HARTFORD PLANNING COMMISSION

Meeting Notice and Agenda

Re: 444 Sykes Mountain Avenue, Lot 45-243 Site Plan Preliminary Comments

Re: 444 Sykes Mountain Avenue, Lot 45-162 Site Plan Preliminary Comments

L1.1

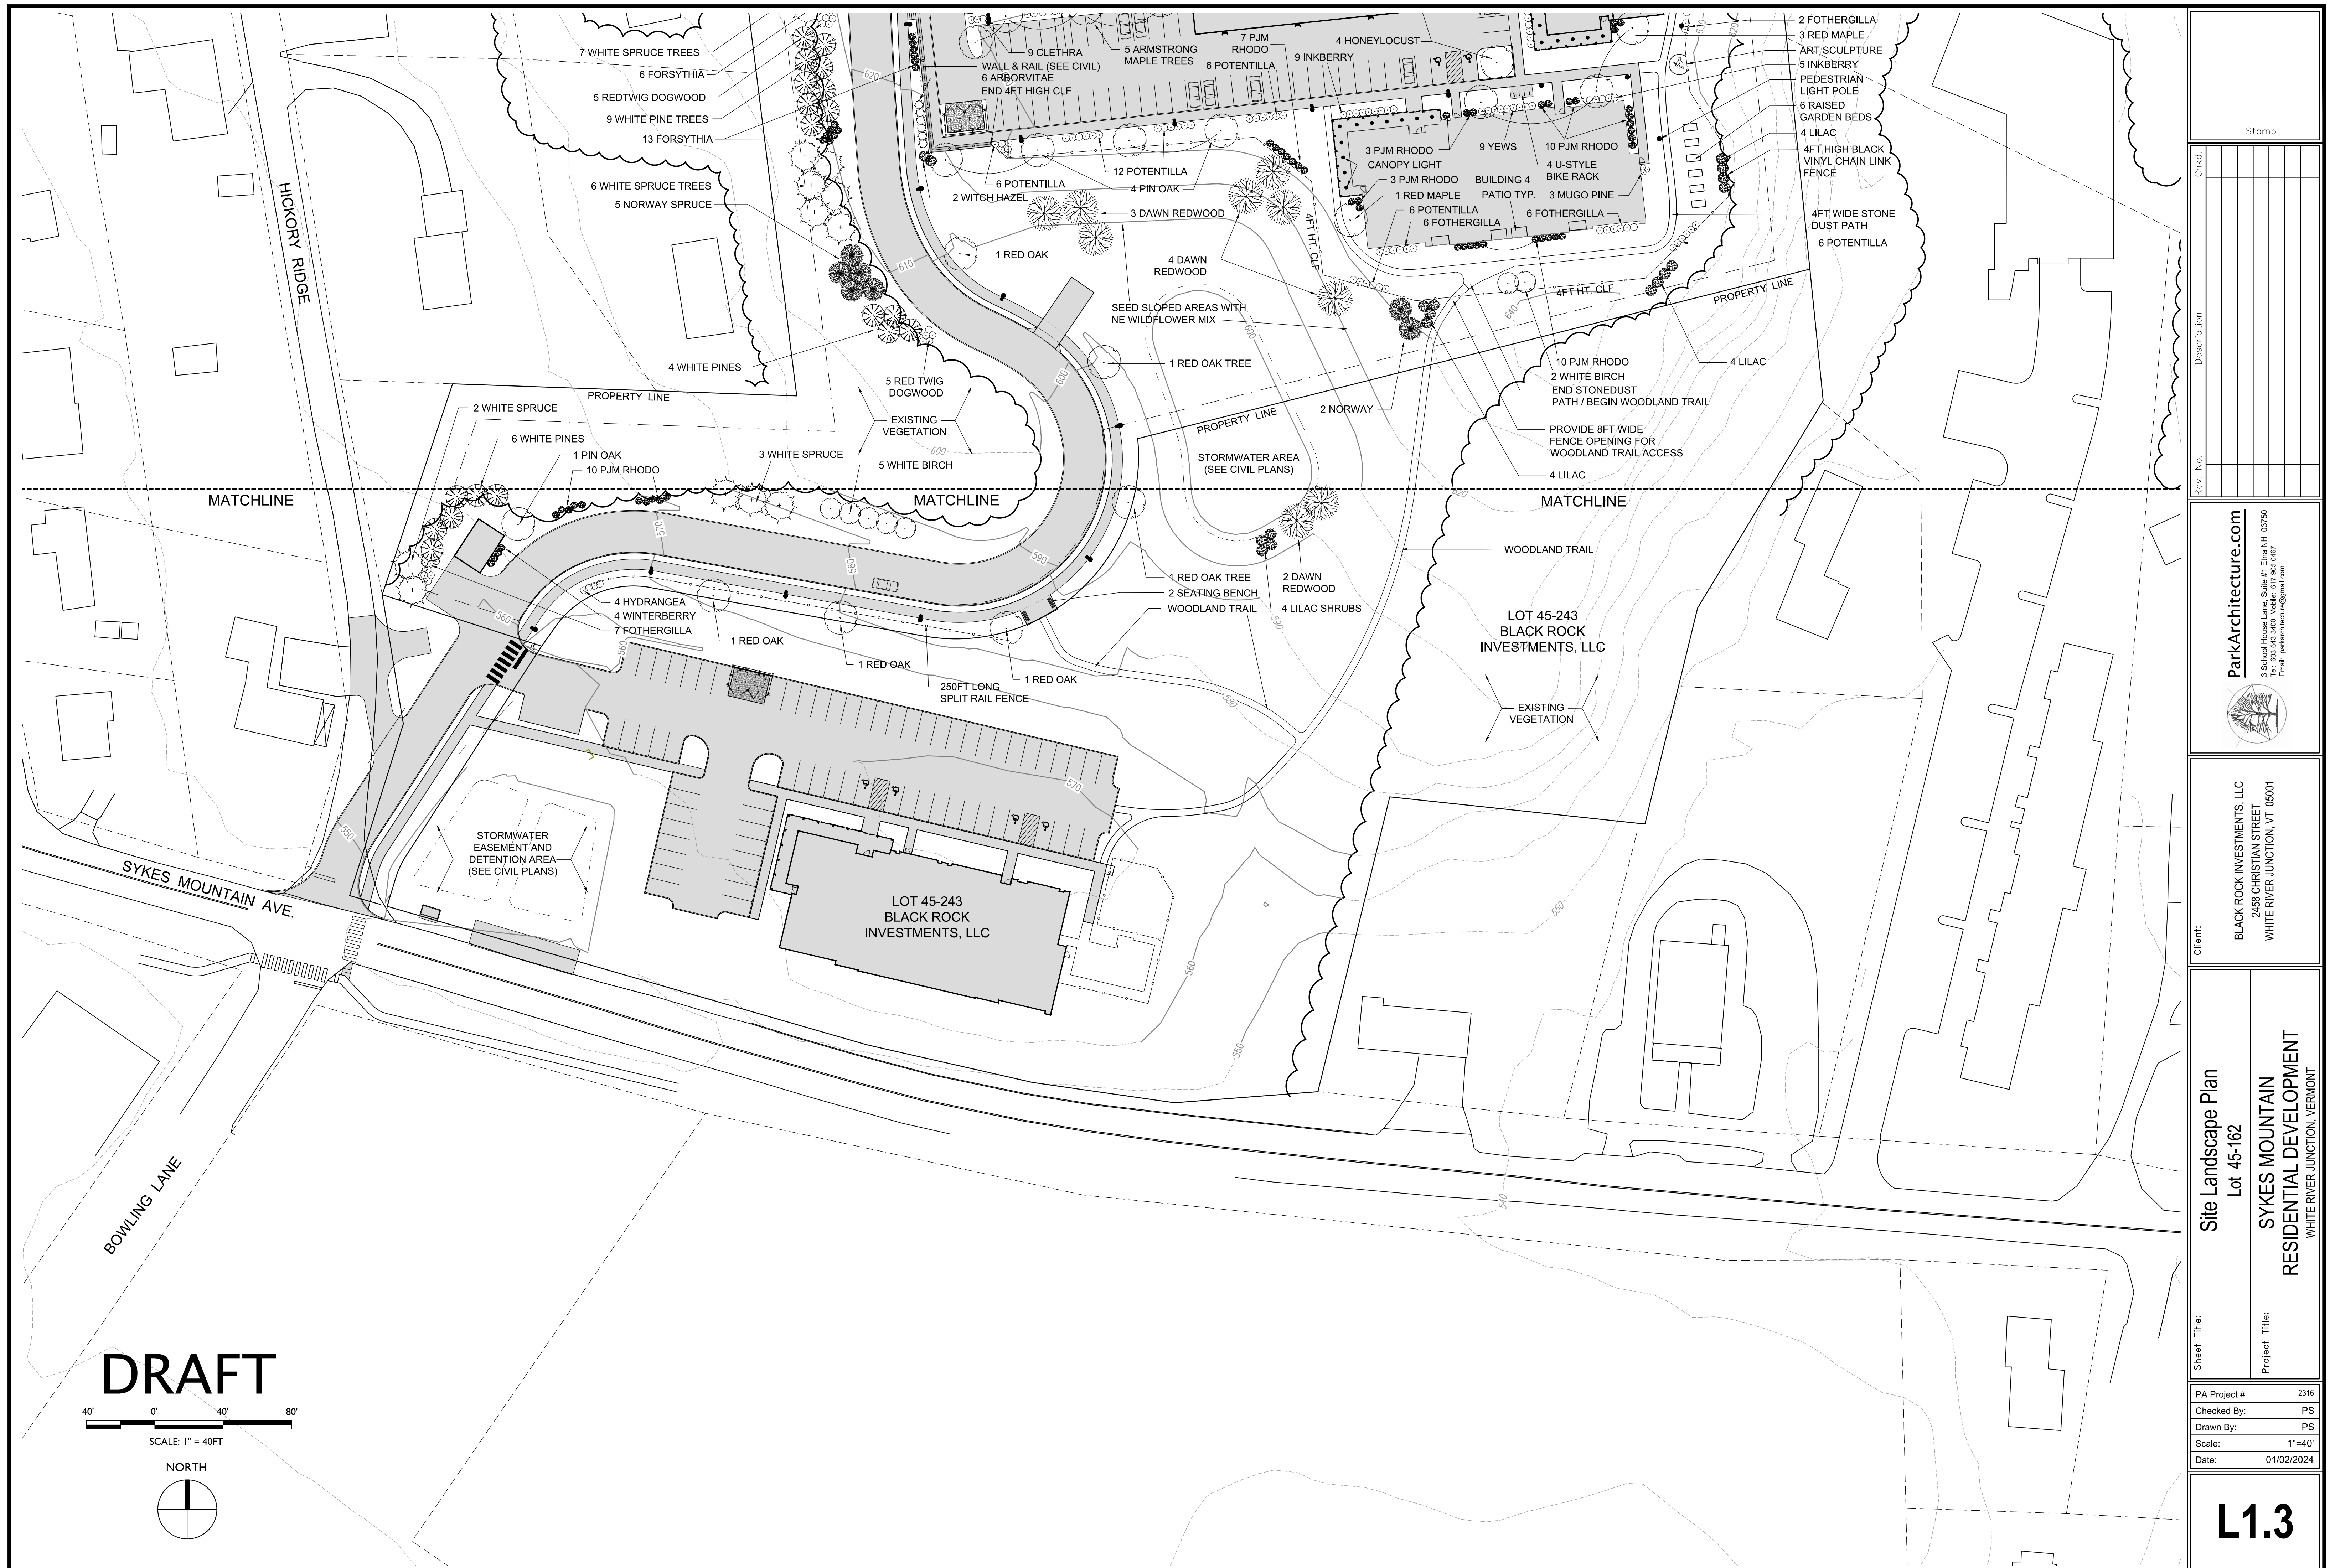
- Consider taller plantings near the retaining wall and on the north side to screen headlights. The retaining wall along the South Side of the parking area has been removed. The building has now been set further away from Sykes Mountain Avenue (further North) to allow sloped plantings. Regardless of the change with removal of the retaining wall, we have rearranged and redesigned the plantings here with taller plantings (Spruce trees) positioned to flank either side of the building and additionally screen the parking area as requested by the board. NE wildflower mixture will be utilized on all steep slope conditions. (See sheet L1.1)
